REFERENCE:	Nova Bus Manuals
SECTION:	16: Electrical system
RS N°:	MQR 7621-619
EFFECTIVE IN PROD.:	N/A

SUBJECT:	N22759 cable protective sheathing
JUSTIFICATION:	The protective sheathing may be damaged and cause error codes on the diagnostic network.

Figure 2 - Location of the +EN-X61AN Connector

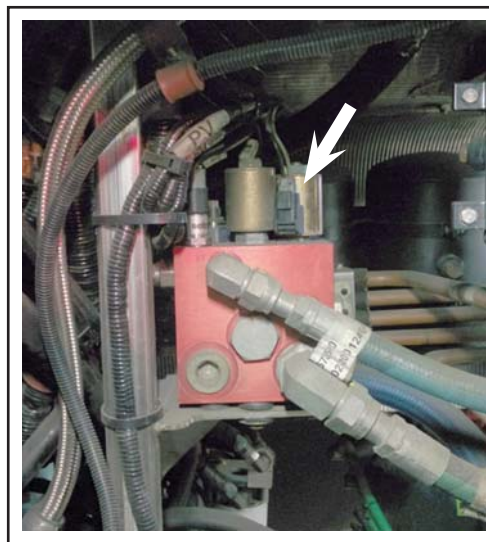
- 1.5. Locate the +EN-X61AN electrical connector on the hydraulic fan control manifold. See Figure 2.

- 1.6. Disconnect the +EN-X61AN electrical connector and cut the two wires from the CAB061BB cable close to the connector shell. See Figure 3. Discard the connector.

Figure 3 - Wires to be Cutted and Insulated on the +EN-X61AN Connector

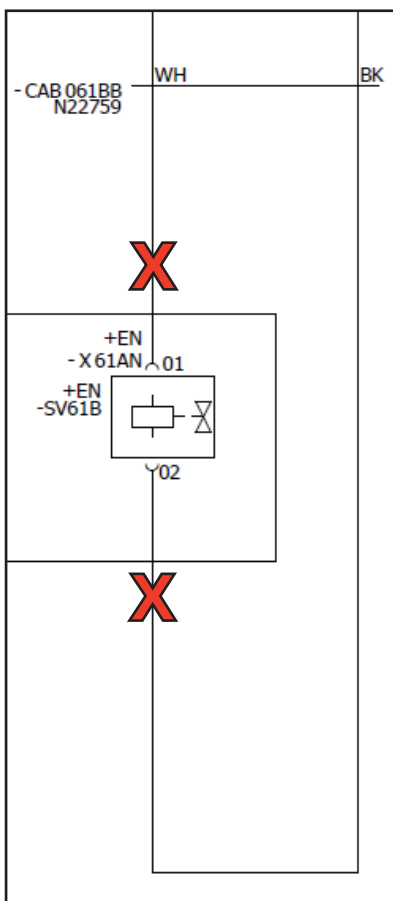
- 1.7. Cut two pieces of N27548-18 heat shrink tubing and install a piece on both cut wires to insulate them properly. See Figures 3 & 4.

Figure 5 - Location of the +MT-X95G (ECM) Connector in the Engine Compartment

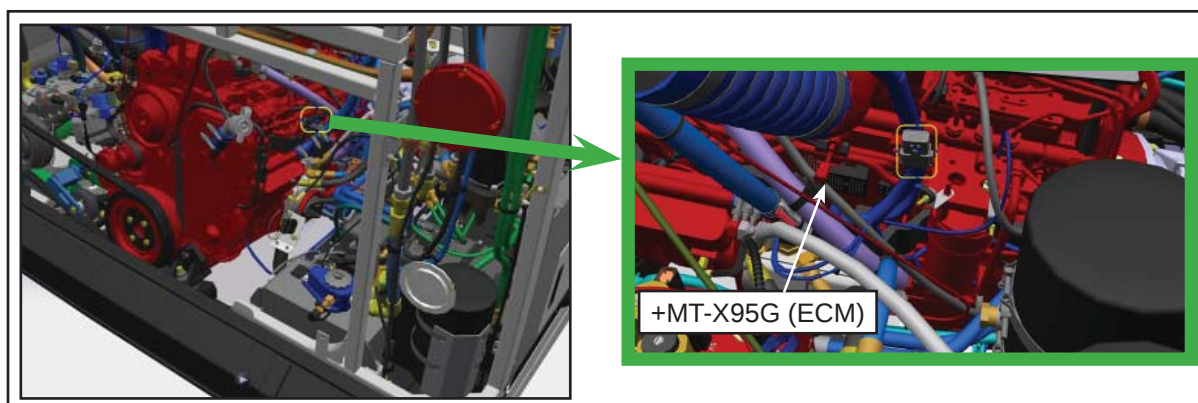
- 1.8. Connect the +EN-X61AN connector from the N632000451 wire kit to the hydraulic manifold.
- 1.9. Locate the +MT-X95G (ECM) electrical connector in the engine compartment. See Figure 5.

Figure 6 - Wires to be Removed and Insulated on +MT-X95G Connector

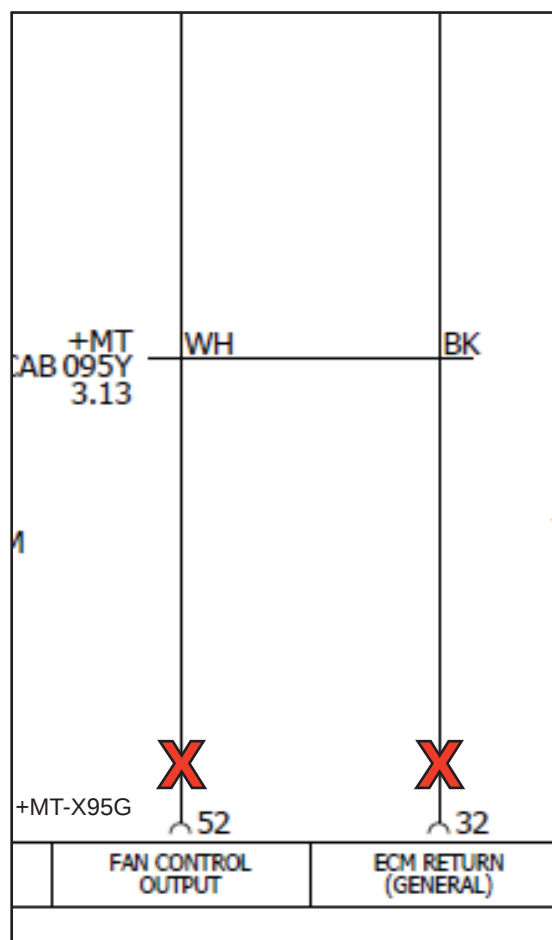
- 1.10. Remove the CAB095Y cable's WH and BK wires from the +MT-X95G connector (positions #52 and #32) using the 04112402005 extractor tool or equivalent. See Figures 6 & 10.

- 1.11. Cut two pieces of N27548-18 heat shrink tubing and install a piece on both wire ends to insulate them properly. See Figures 4 & 6.
- 1.12. Route the new N632000451 wire kit with a loop. Attach it to the metal structure, go under the +MT-X9564A/61A connector and follow the other vehicle wiring up to the +MT-SC95C connector. See Figure 7. Secure the wire kit with G5007996 cable ties.

- 1.13. Install the WH wire (95-346) in the position #52 and the BK wire (95-345) in the position #32 of the +MT-X95G connector..
- 1.14. Locate the +MT-X9561A connector in the engine compartment. See Figure 8.

Figure 9 - Wires to be Cut and Insulated, and Sealing Plugs to be Installed on +MT-X9561A Connector

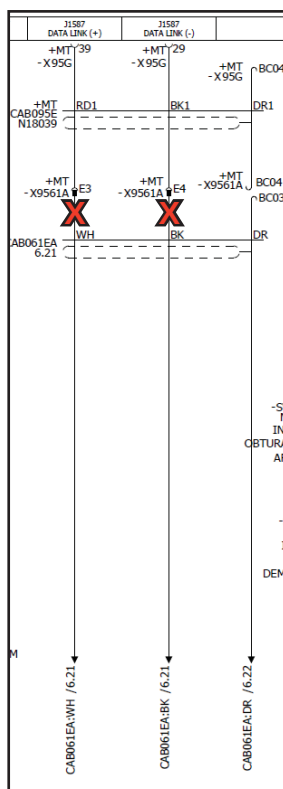
- 1.15. Remove the pins in positions E3 and E4 of the +MT-X9561A connector using the 682256 extractor tool or equivalent. See Figures 9 & 10.

- 1.16. Install a 12059168 sealing plug in positions E3 & E4 of the +MT-X9561A connector. See Figure 9.
- 1.17. Cut the pins on the two removed wires (positions E3 & E4 of the +MT-X9561A connector). See Figure 9.
- 1.18. Cut two pieces of N27548-18 heat shrink tubing and install a piece on both wire ends to insulate them properly. See Figures 4 & 9.

Figure 11 - Location of the +IB-X6199A Connector on the Engine Control Module

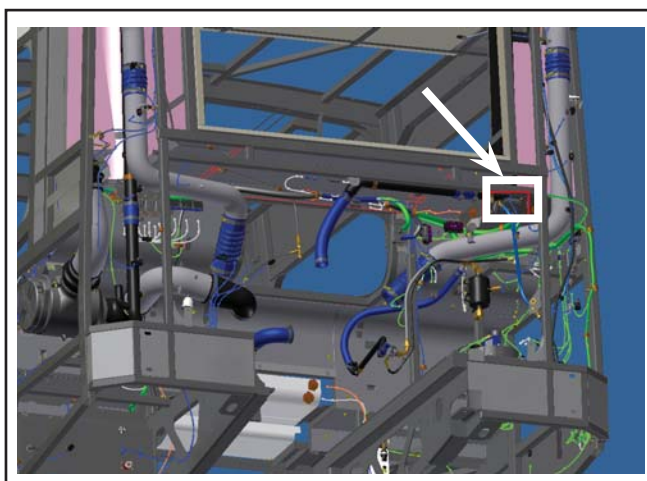
- 1.19. Locate the +IB-X6199A connector in the engine compartment. See Figure 11.

Figure 12 - Wires to be Cut and Insulated, and Sealing Plugs to be Installed on the +IB-X6199A Connector

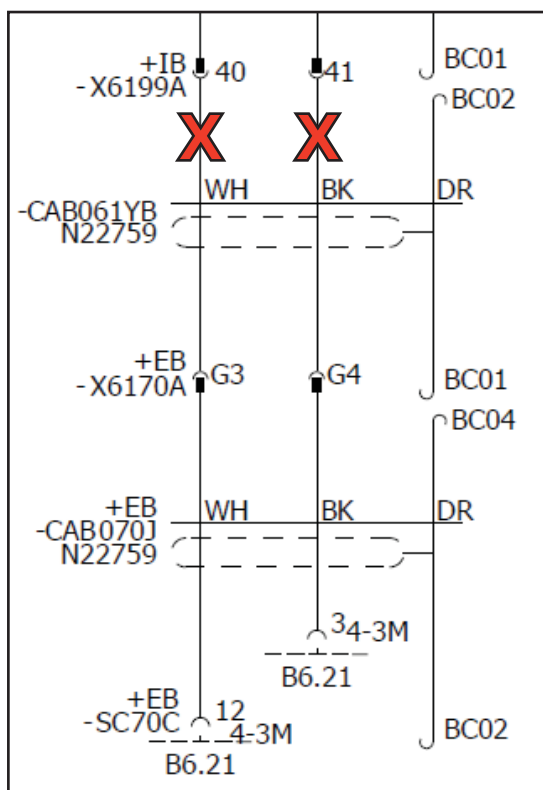
- 1.20. Remove the pins in positions 40 & 41 of the +IB-X6199A connector using the N8904487 extractor tool or equivalent. See Figures 10 & 12.

- 1.21. Install a 562288 sealing plug in positions 40 & 41 of the +IB-X6199A connector. See Figure 12.
- 1.22. Cut the pins on the two removed wires (positions 40 (WH) & 41 (BK) of the +IB-X6199A connector). See Figure 12.
- 1.23. Cut two pieces of N27548-18 heat shrink tubing and install a piece on both wire ends to insulate them properly. See Figures 4 & 12.
- 1.24. Locate the +EB-X70A connector in the engine compartment. See Figure 13.

Figure 14 - Wires to be Cut and Insulated, and Sealing Plugs to be Installed on the +EB-X70A Connector

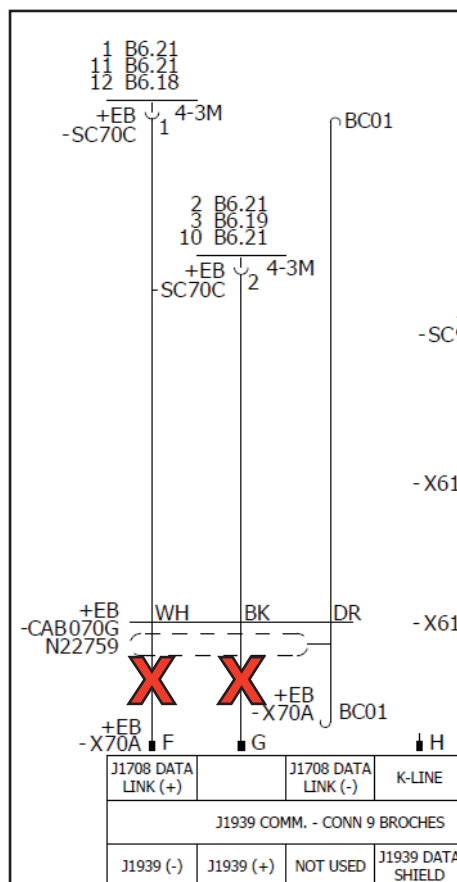
- 1.25. Remove the pins in positions F & G of the +EB-X70A connector using the 682321 extractor tool or equivalent. See Figures 10 & 14.
- 1.26. Install a 562288 sealing plug in positions F & G of the +EB-X70A connector. See Figure 14.
- 1.27. Cut the pins on the two removed wires (positions F & G of the +EB-X70A connector). See Figure 14.
- 1.28. Cut two pieces of N27548-18 heat shrink tubing and install a piece on both wire ends to insulate them properly. See Figures 4 & 14.
- 1.29. Close the engine compartment.
- 1.30. Enable the vehicle's electrical system by selecting the ON position at the battery main switch.
- 1.31. The vehicle may be returned to service. ❖
